Preliminary Drainage Report Guntzelman Porcelain Pines Subdivision

Add PCD File No.
SP-225

SHEET # **FIG. 1**

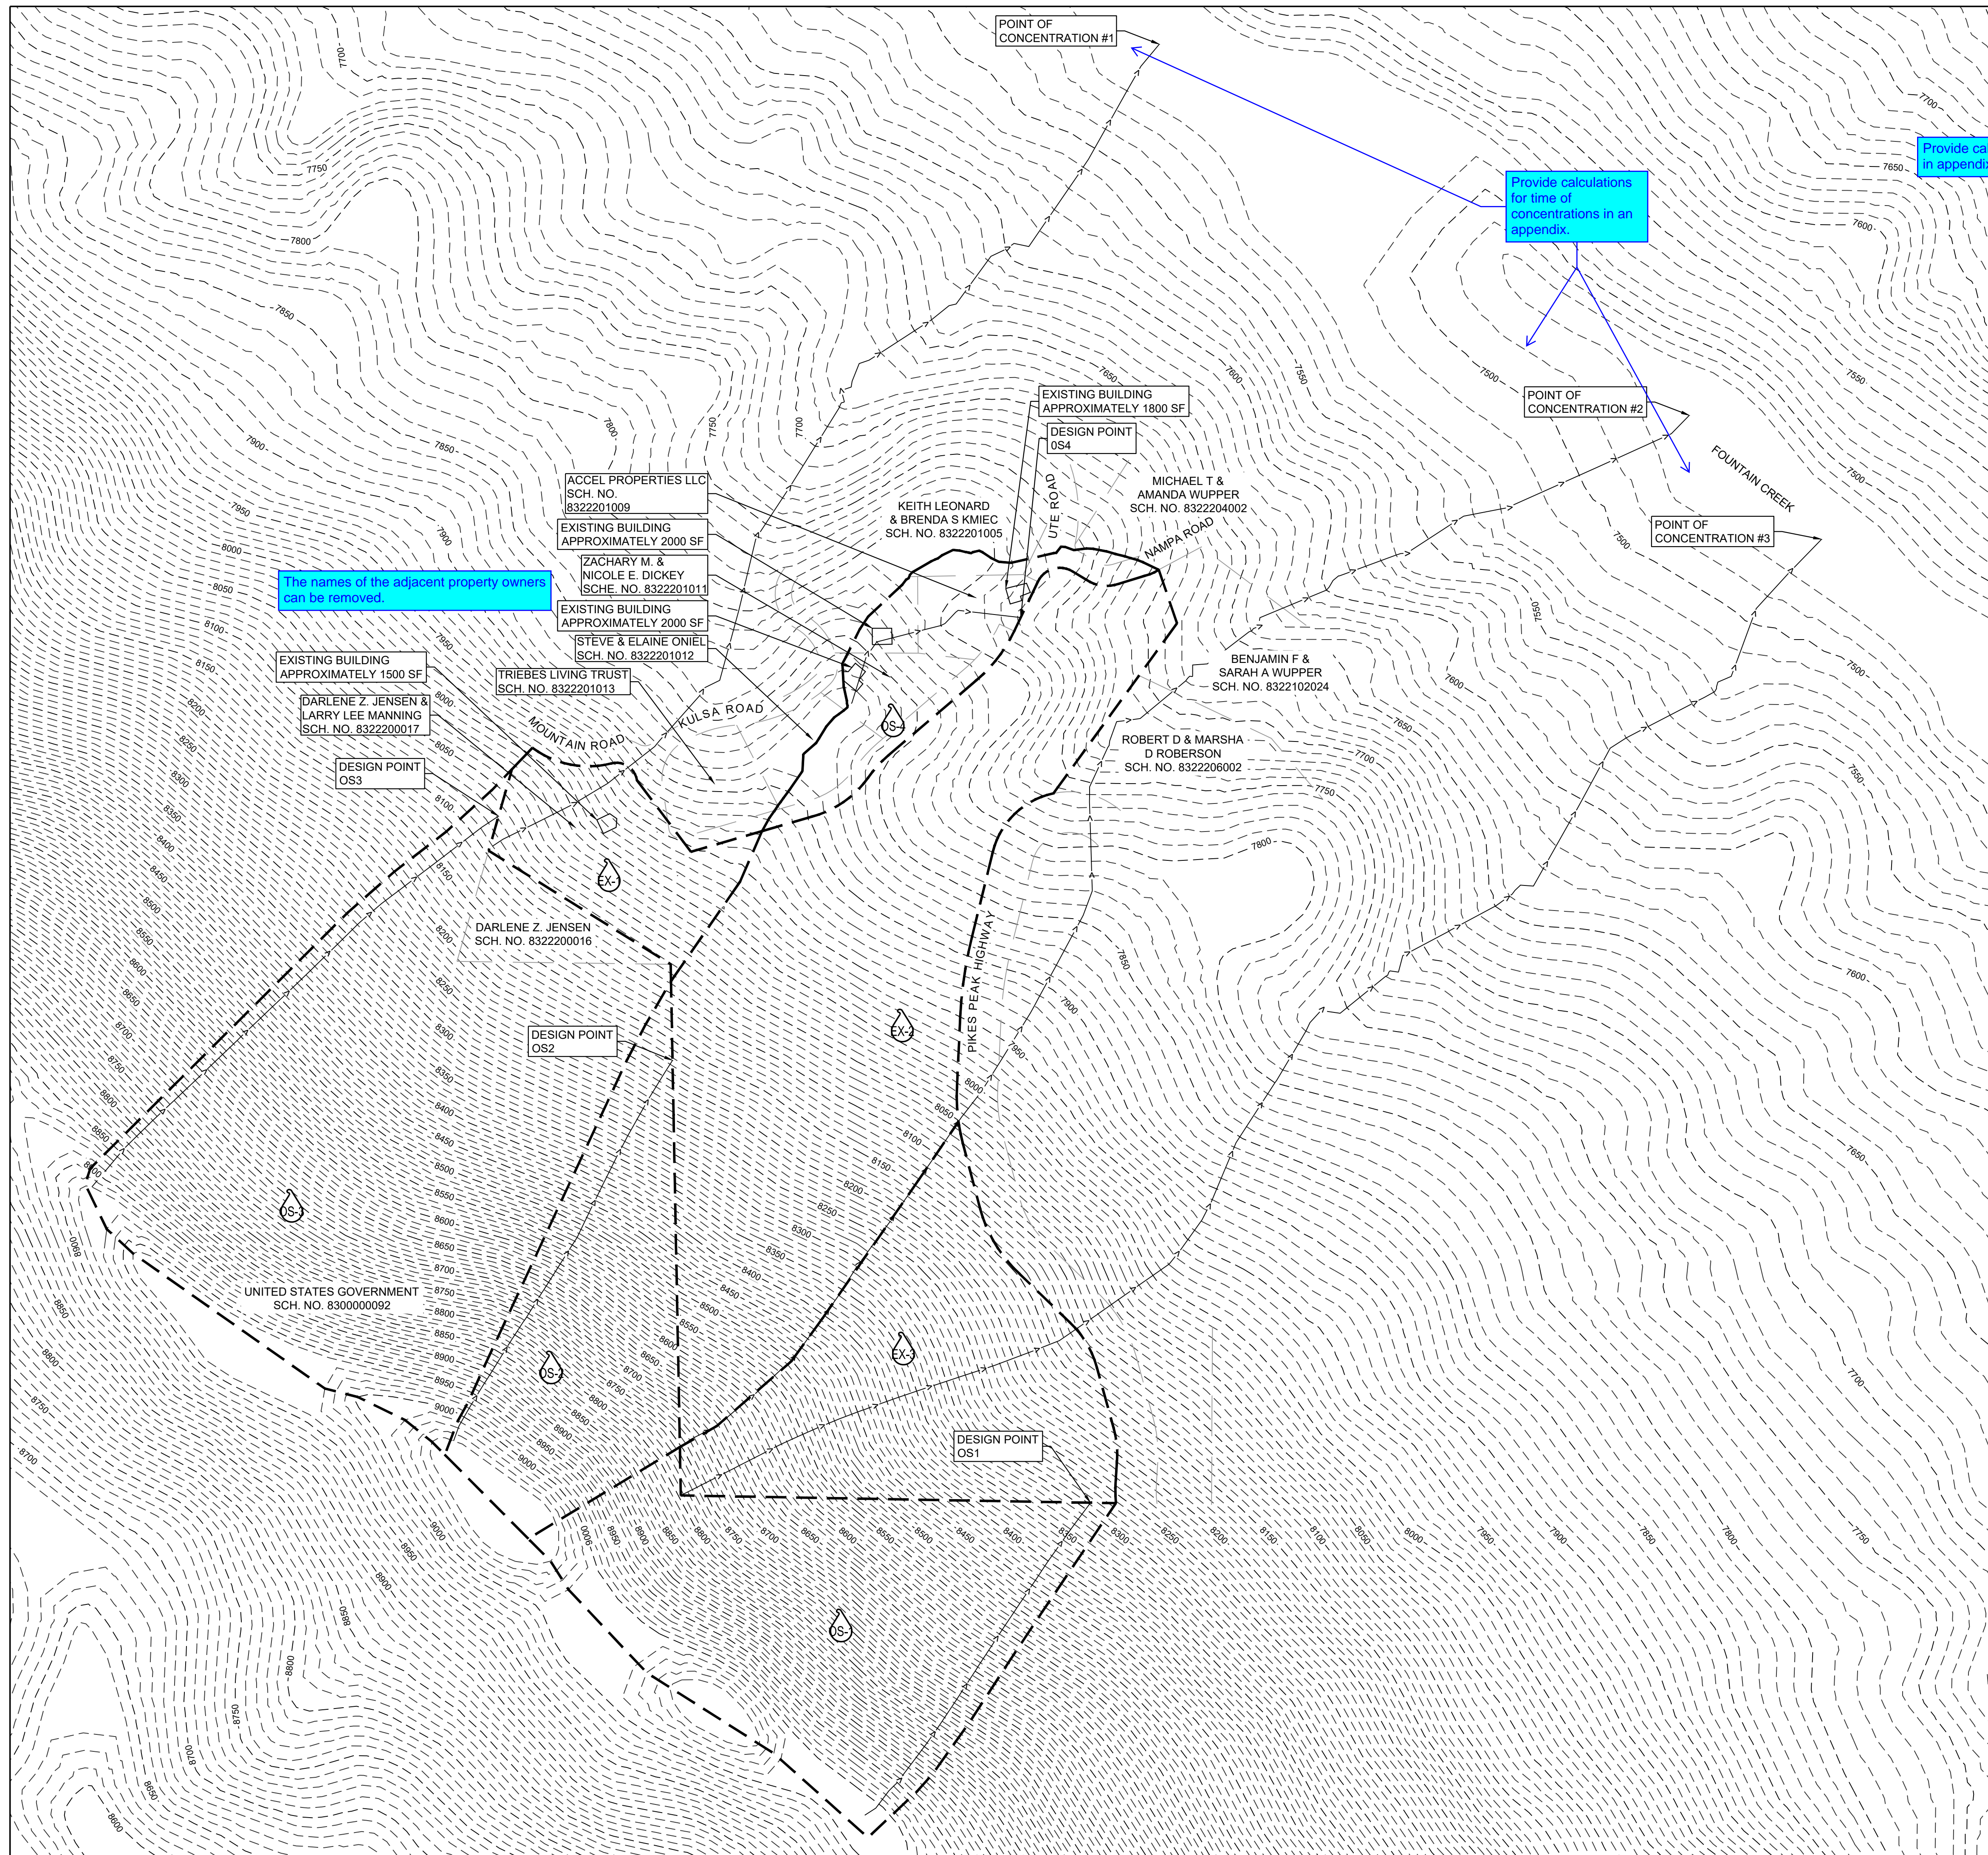
The names of the adjacent property owners can be removed.

Provide calculations for time of concentrations in an appendix.

Provide calculations in appendix.

SHEET # **FIG. 2**

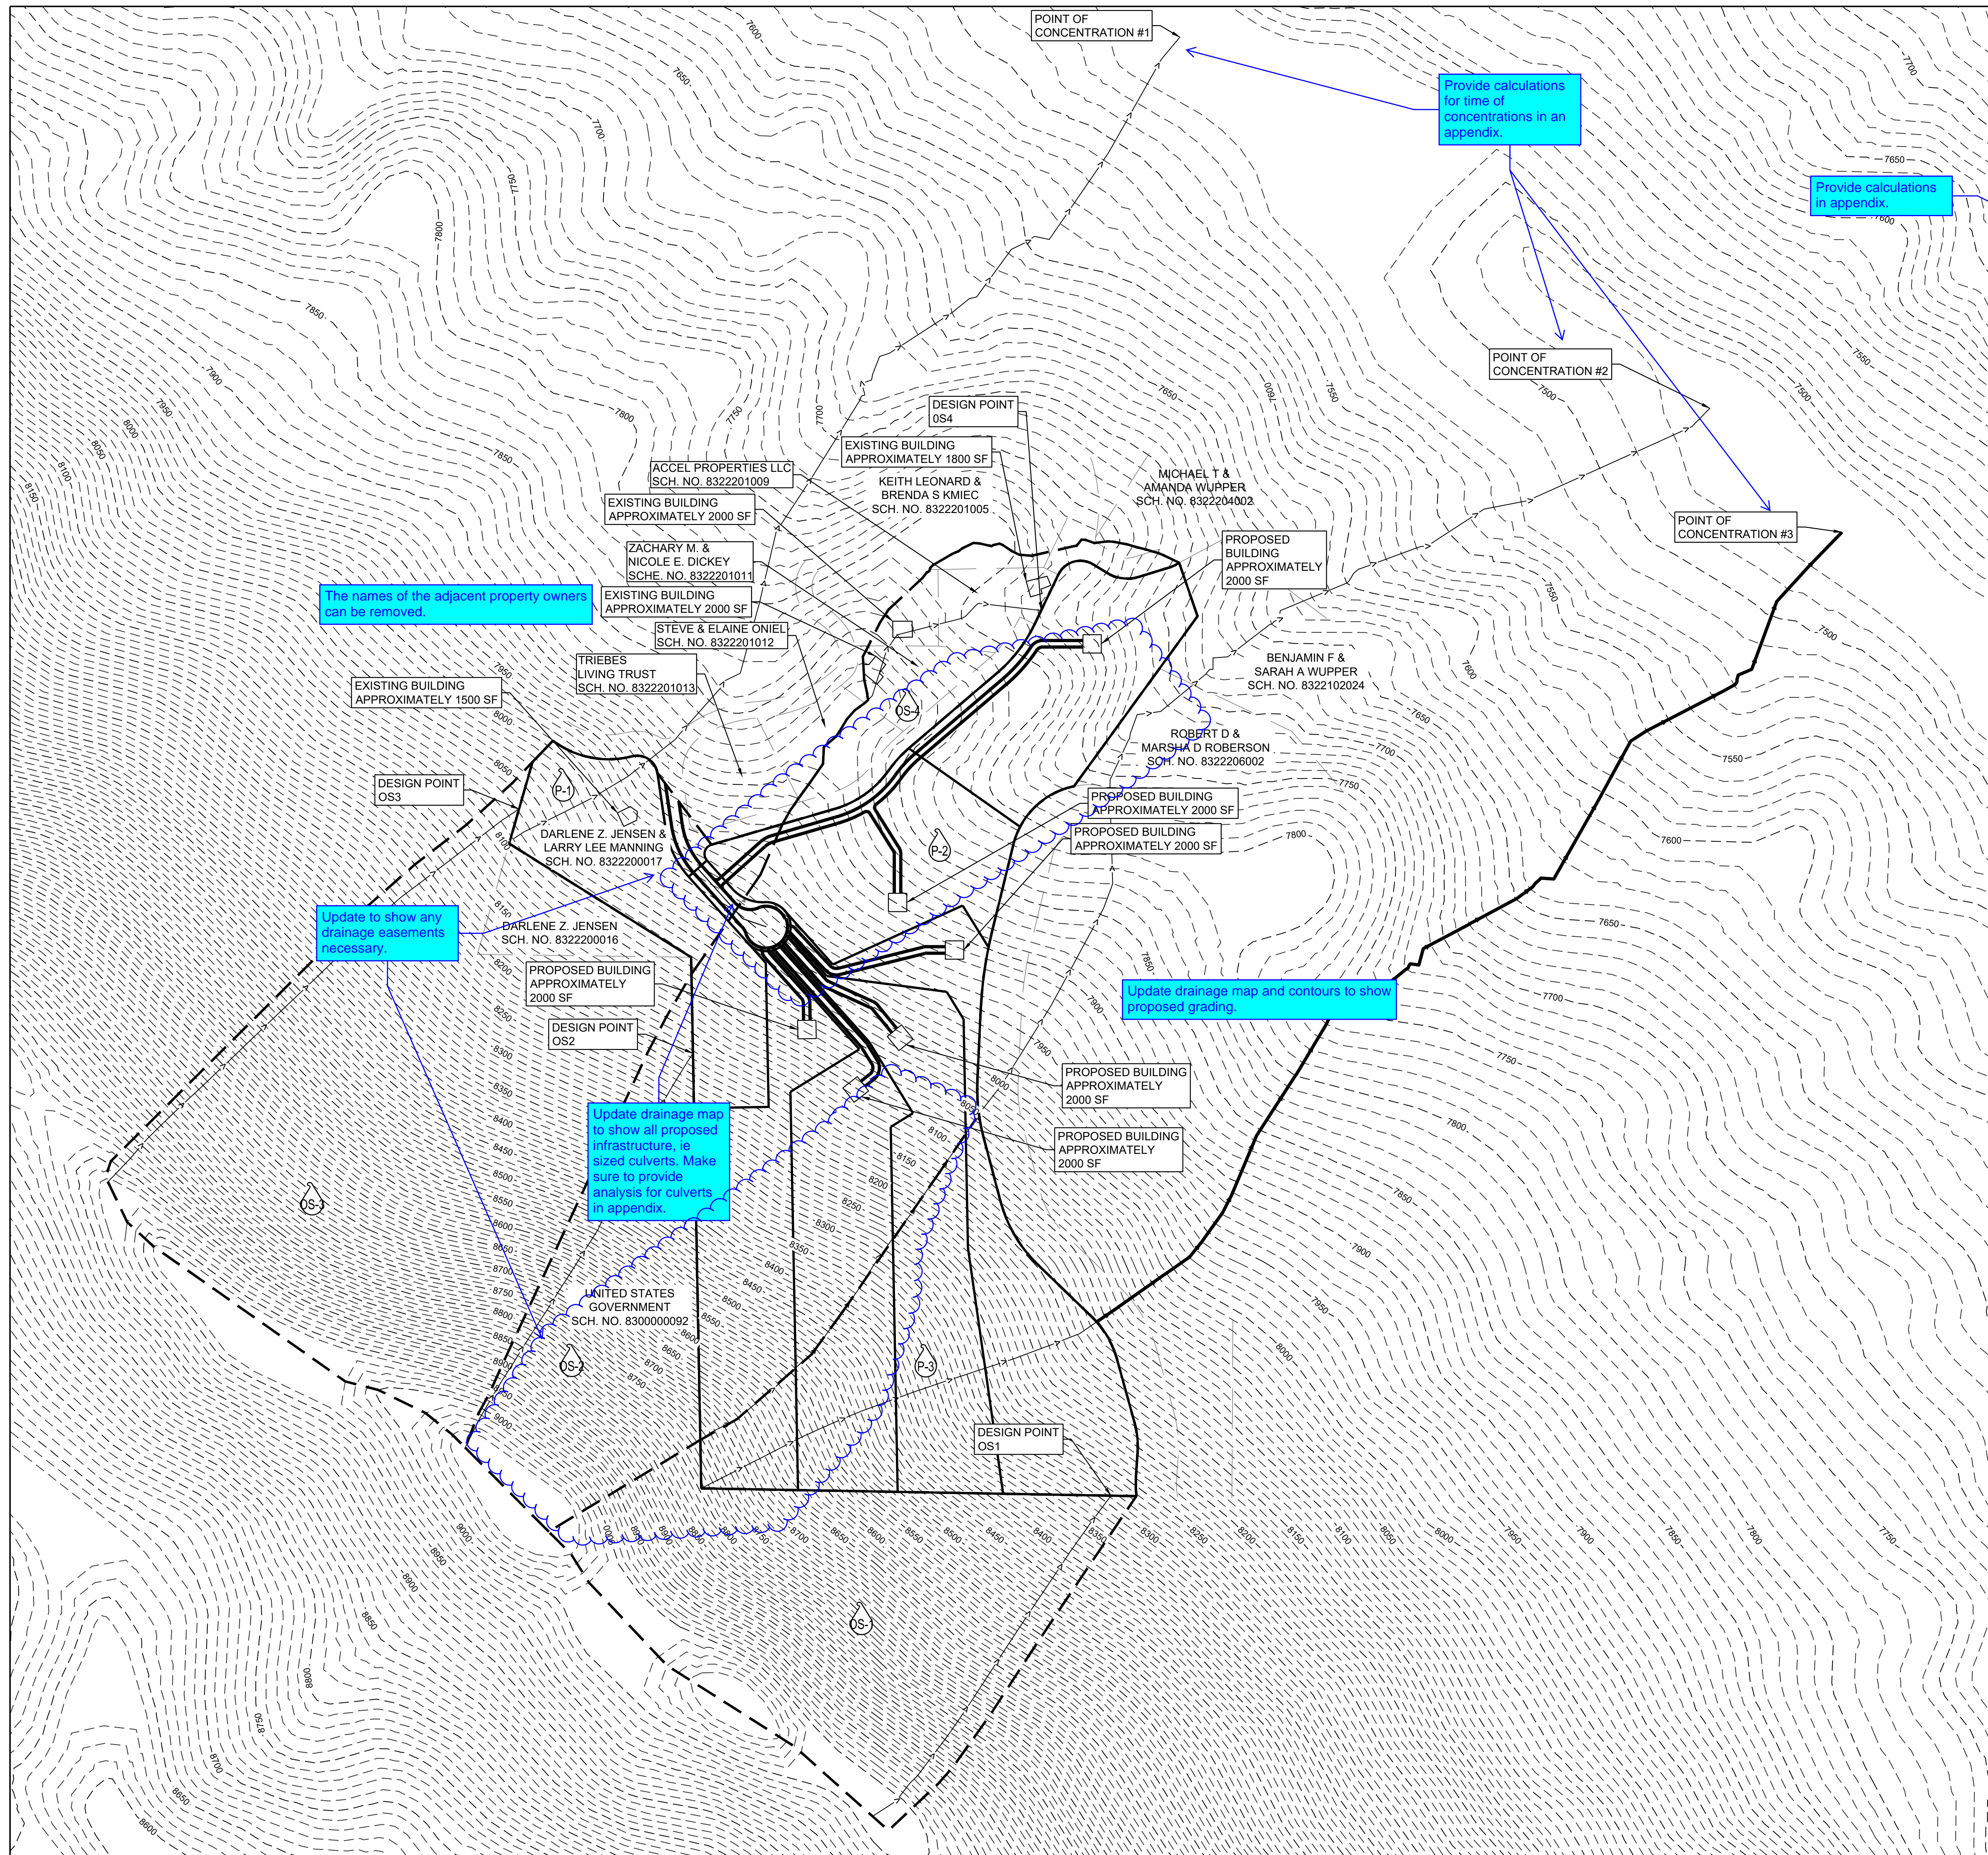
Per ECM 3.3.4.A any areas with 15 cfs or larger require drainage easements. Show delineated drainage easements on drainage map and show easements on preliminary plan.

Provide drainage flow arrows.
